no:	Revision	Date:	
architecture & design services ltd.			
PROJECT:	Relubrication Canons Brook Golf Club Elizabeth Way Harlow Essex CM19 5BE		
DRAWING:	PROPOSED Floor Plans & Indicative Sections		
DRAWN BY:	mwc	CHECKED:	mwc
DATE:	SEPTEMBER 2009		
SCALE:	1/50		
DRAWING NUMBER:	08/040/A/003A		
	Pamdon Mill, Harlow, Essex, CM20 2HP

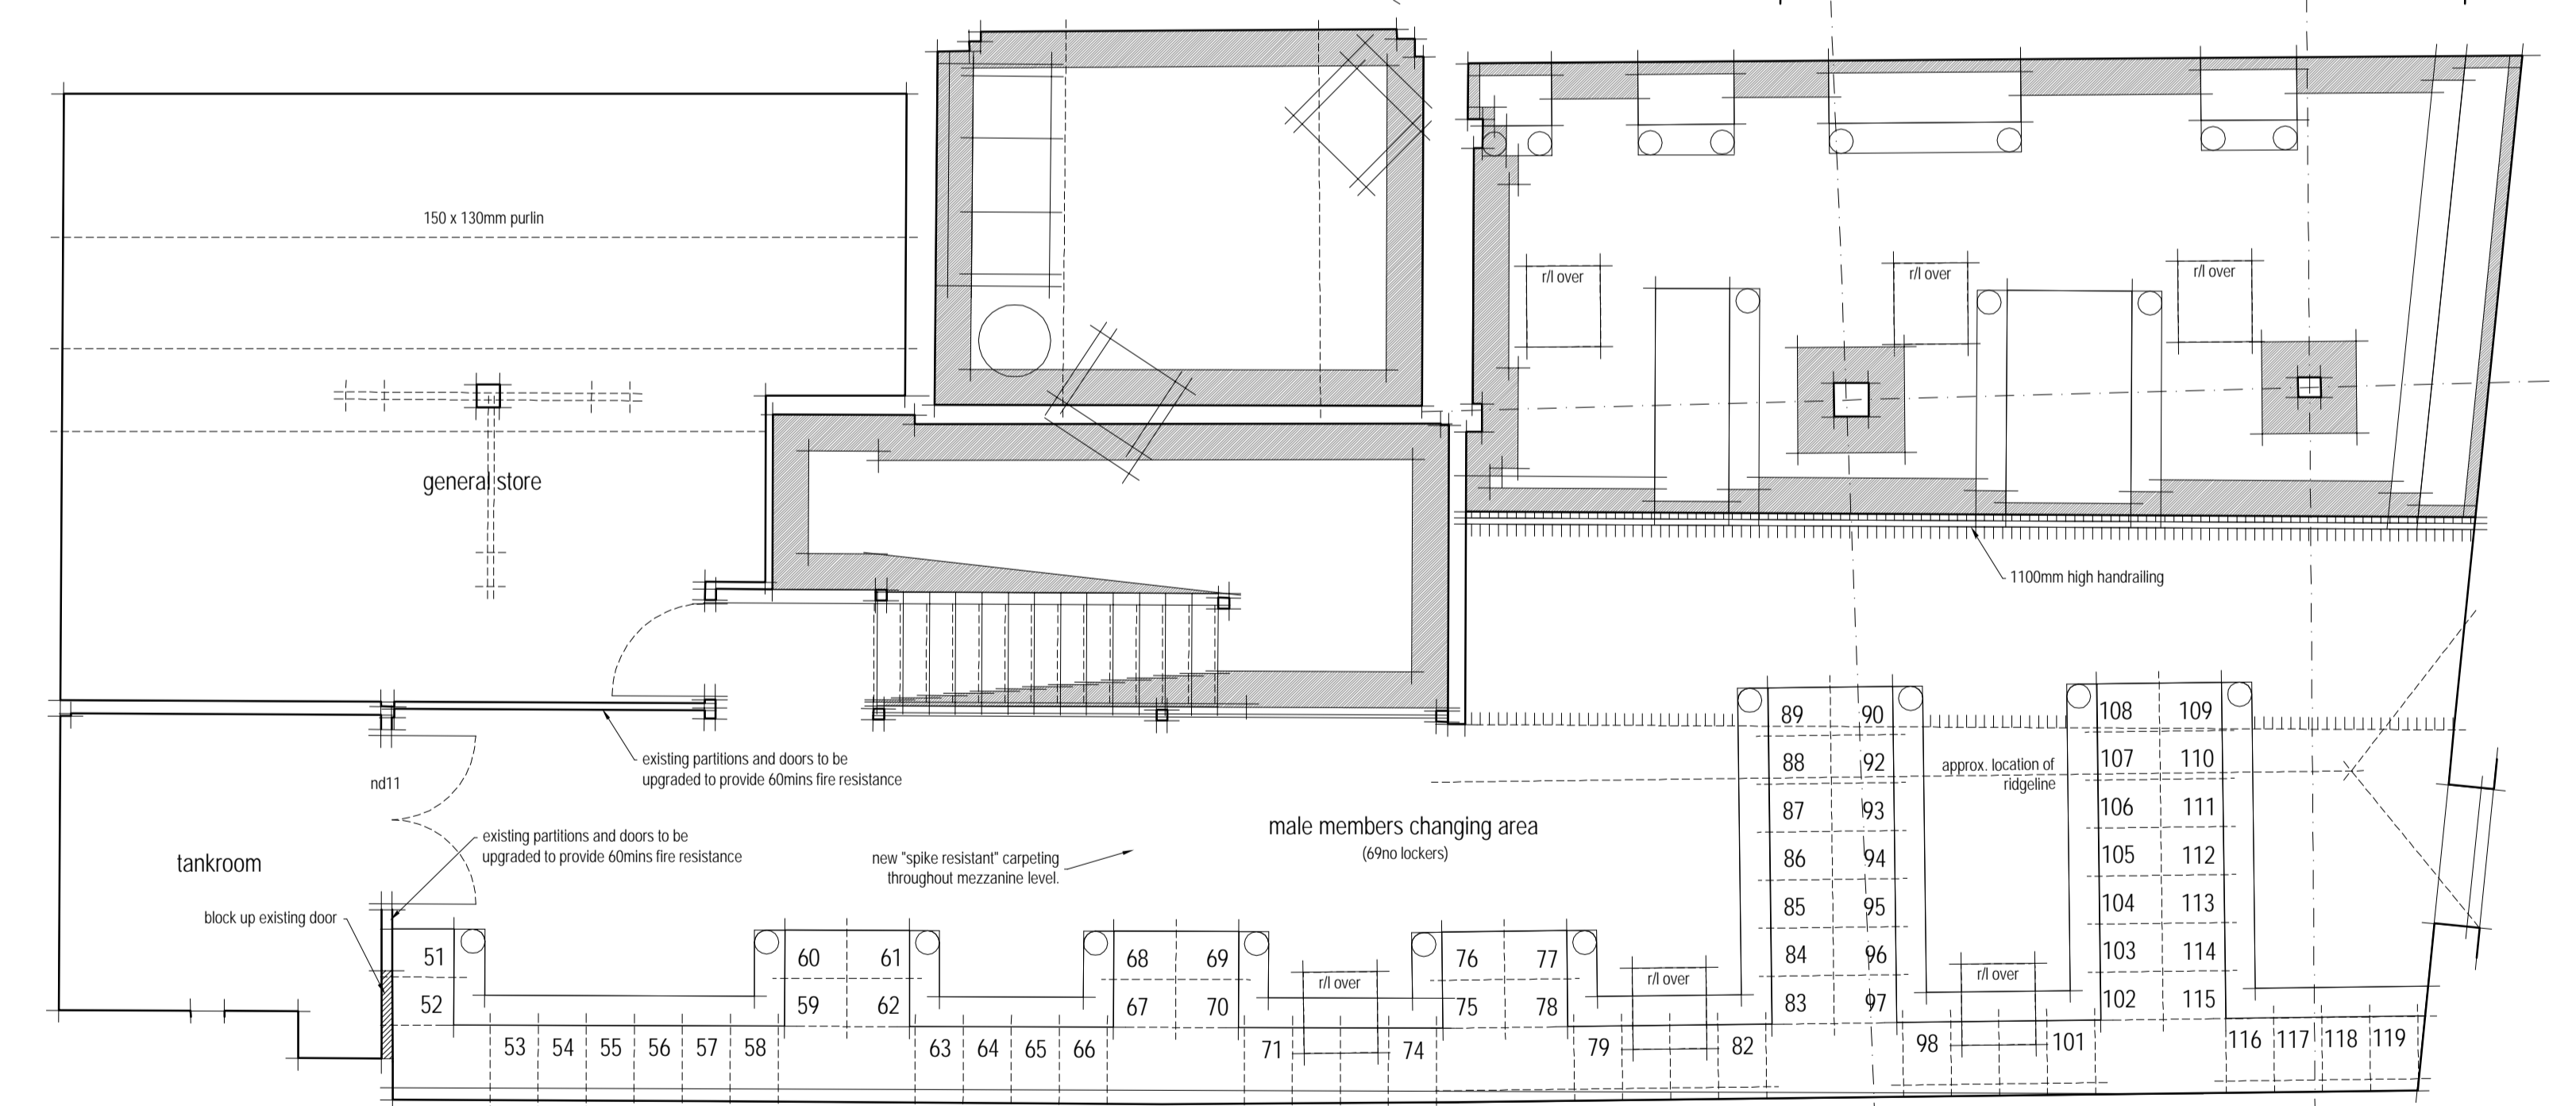
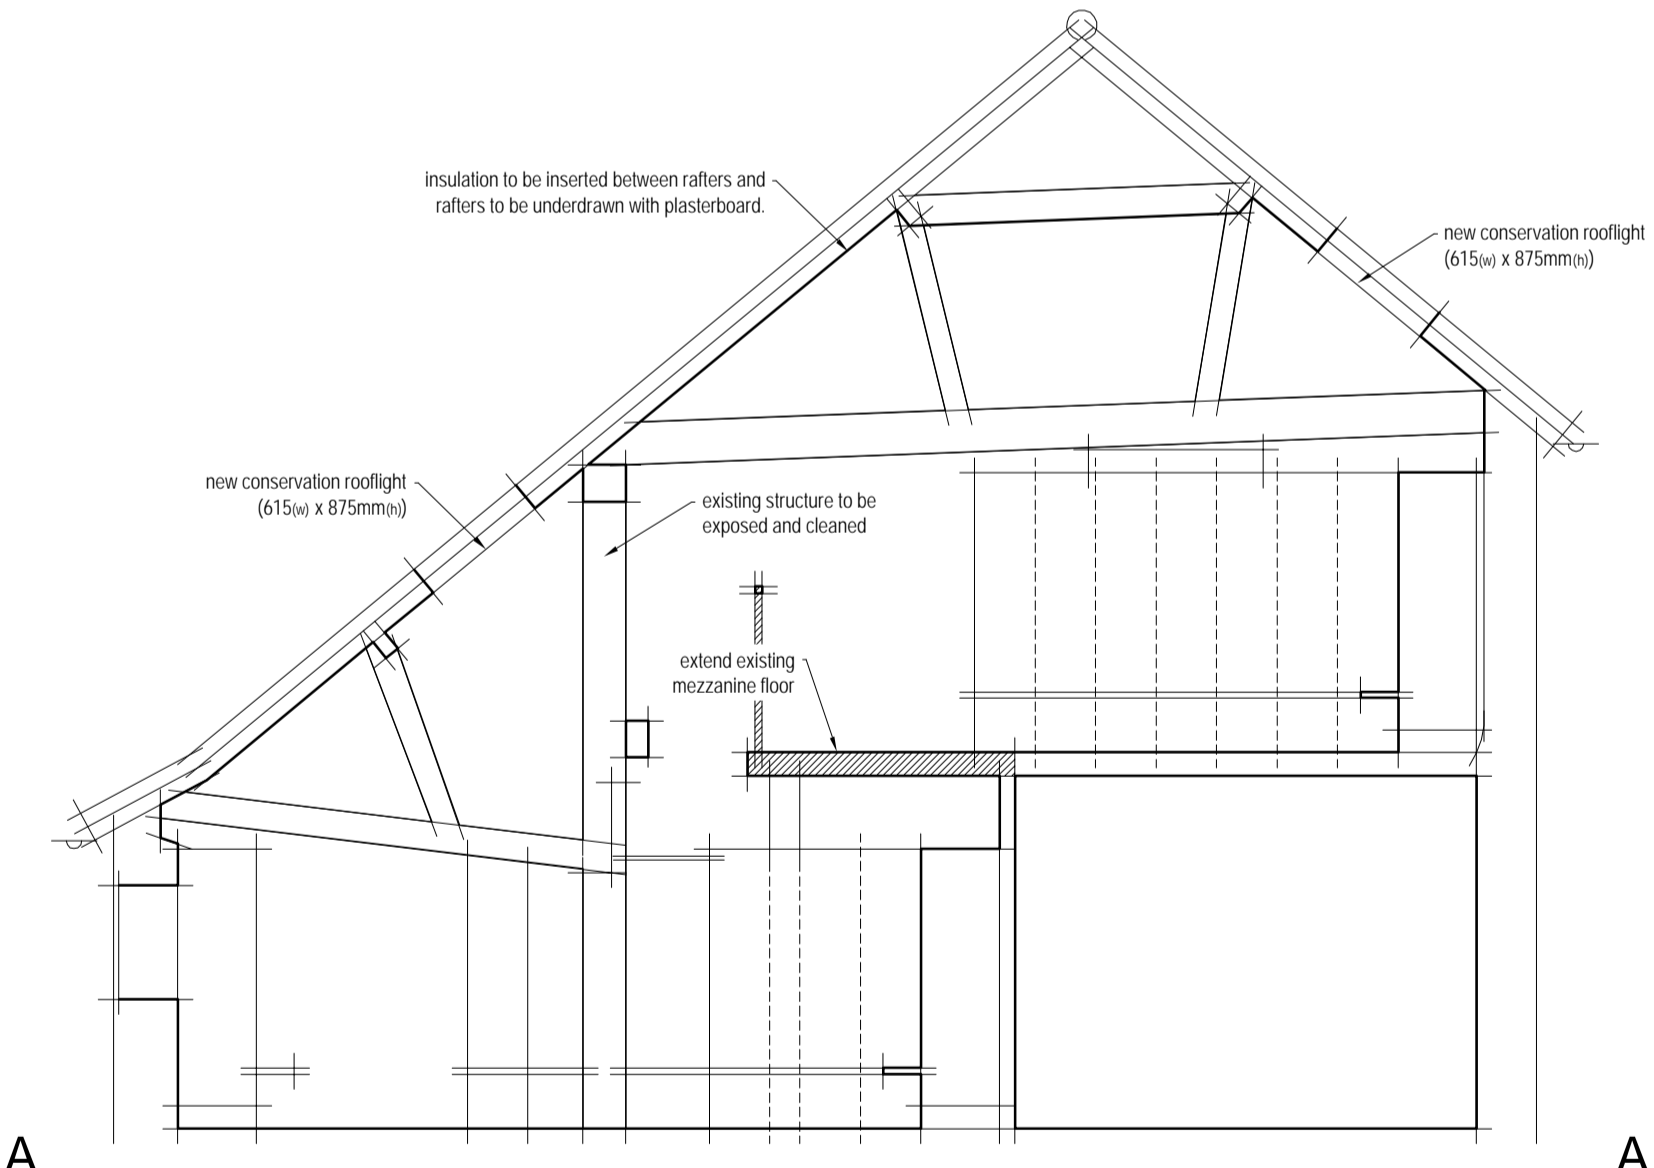
revision #1: male changing area, we arrangement revised to accommodate client changes; first floor 'store' revised to 'tankroom' following comments by m&e engineers; doors to 'tankroom' added; locker provision to first floor area revised; notes revised generally.
 28th november 2009 - mwc
